A. Amendments to the Drawings

Serial No. 10/724,496 filed 11/28/2003
VEHICLE DOOR ARRANGEMENT
Applicant: Milolai, et al
Attorney: Ernest E. Helms (248) 203-0756
Docket No. 201-0911
Annotated Sheet 3 of 14

FIG. 4

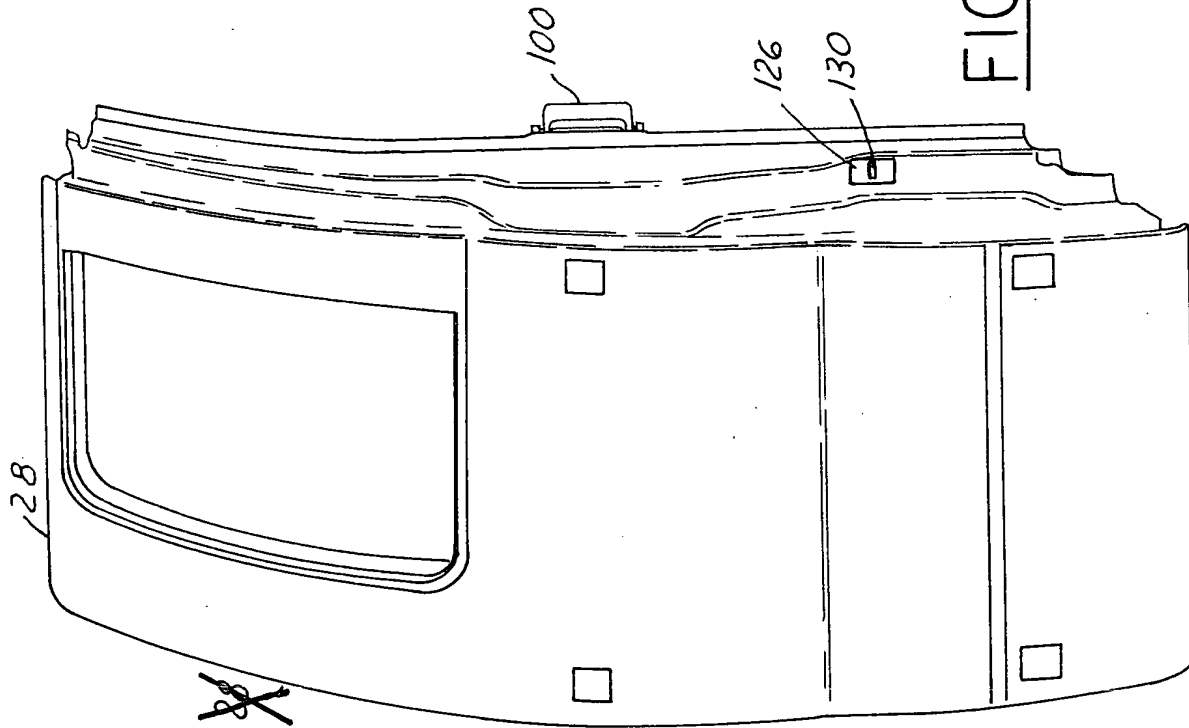
Figure 4: The lowermost "28" has been deleted.

FIG. 5

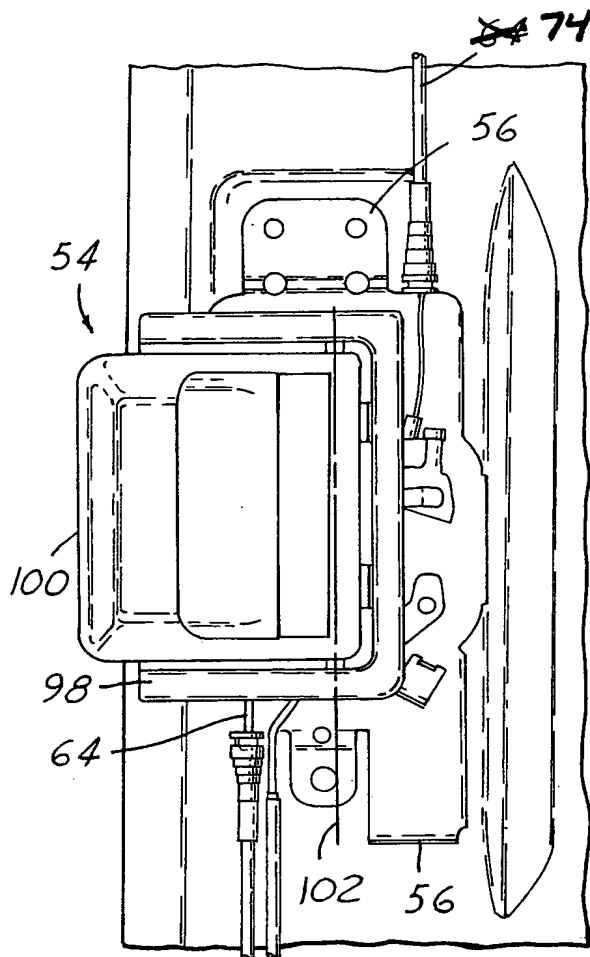
Figure 5: A lead line has been added to "46".

FIG. 9

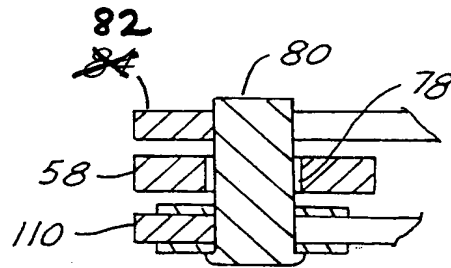
Figure 9: Reference number "84" has been changed to "82".

FIG. 13

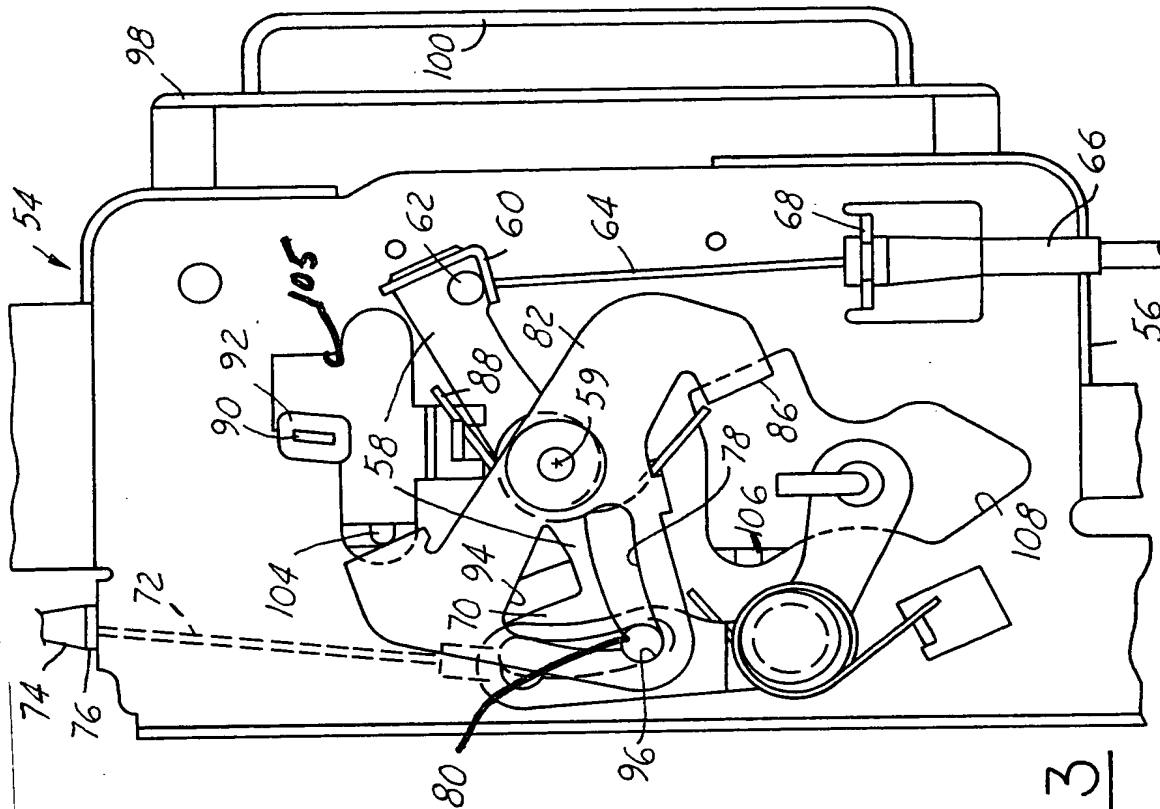
Figure 13: The lead line for reference number "80" has been extended. A lead line has been added for "106". Reference item "105" has been added.

FIG. 21

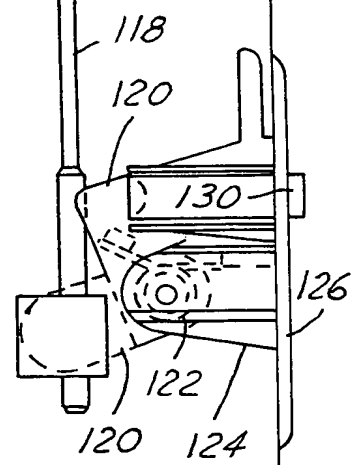
Figure 21: Reference number "94" has been changed to "59" and reference number "96" has been changed to "78".

FIG. 27

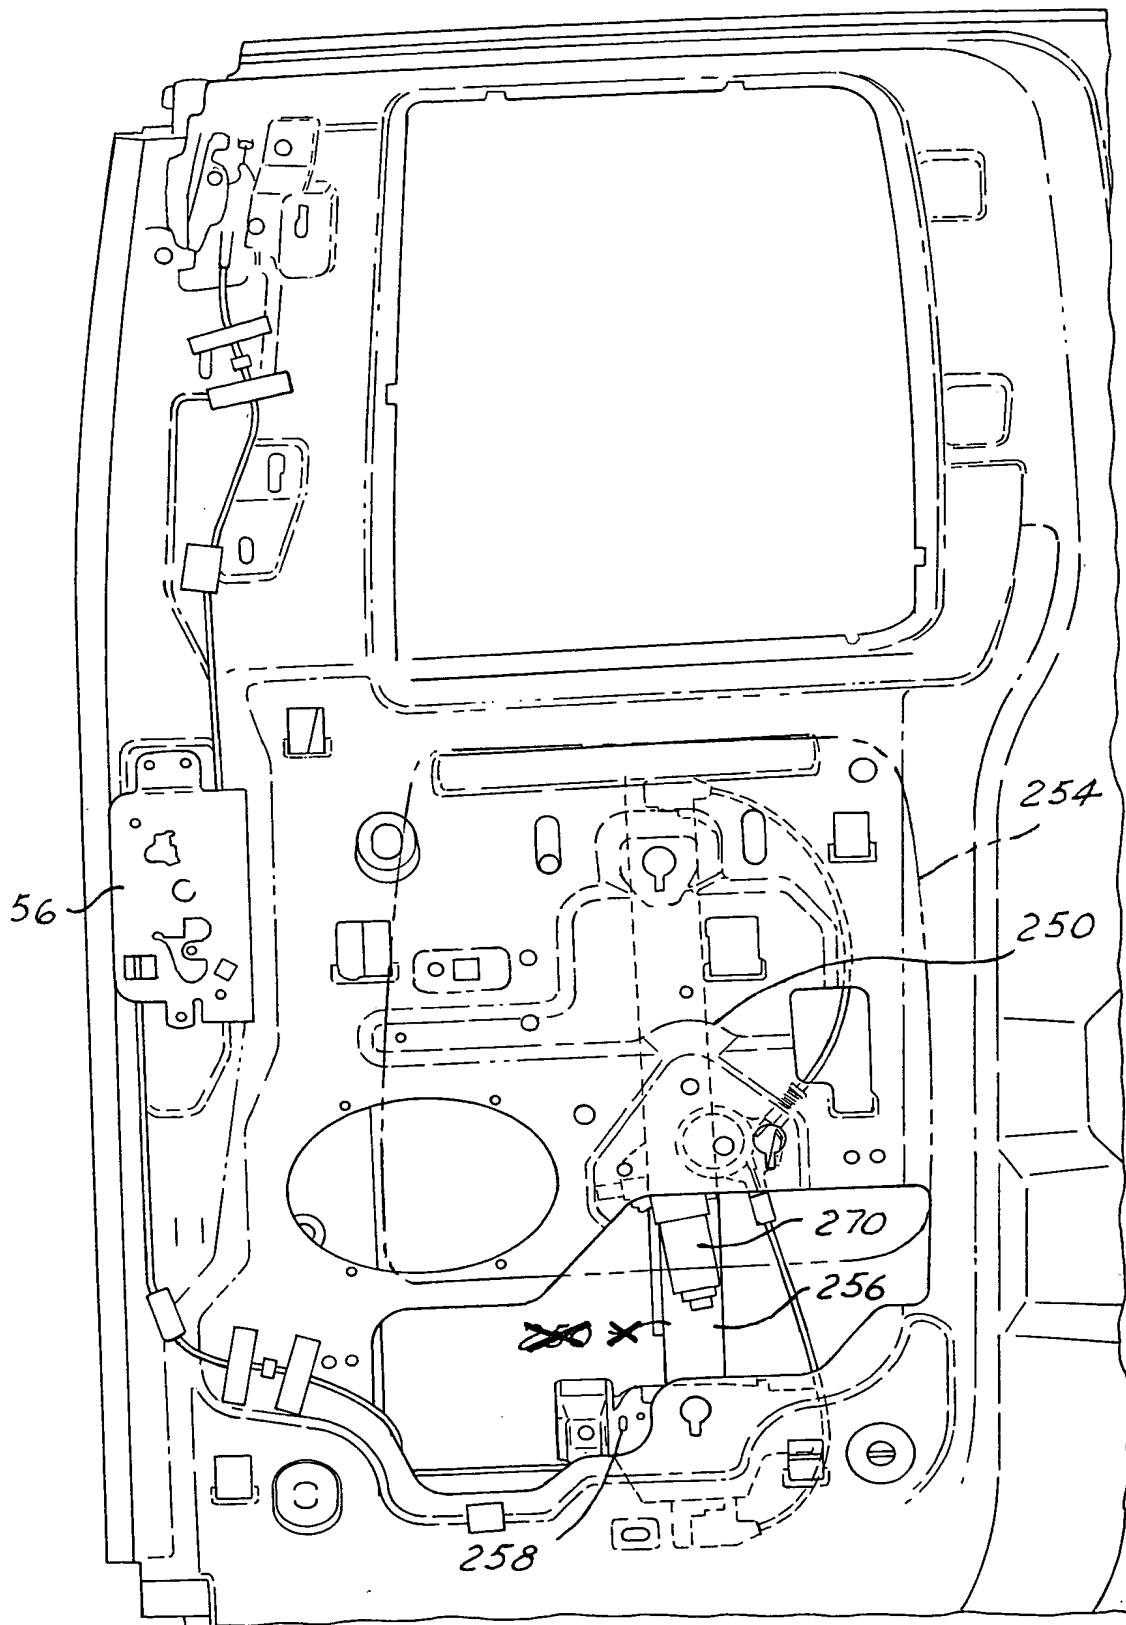
Figure 27: The lowermost reference number "250" and its lead line have been deleted.

Figure 27: Reference number "270" has been changed to "271".
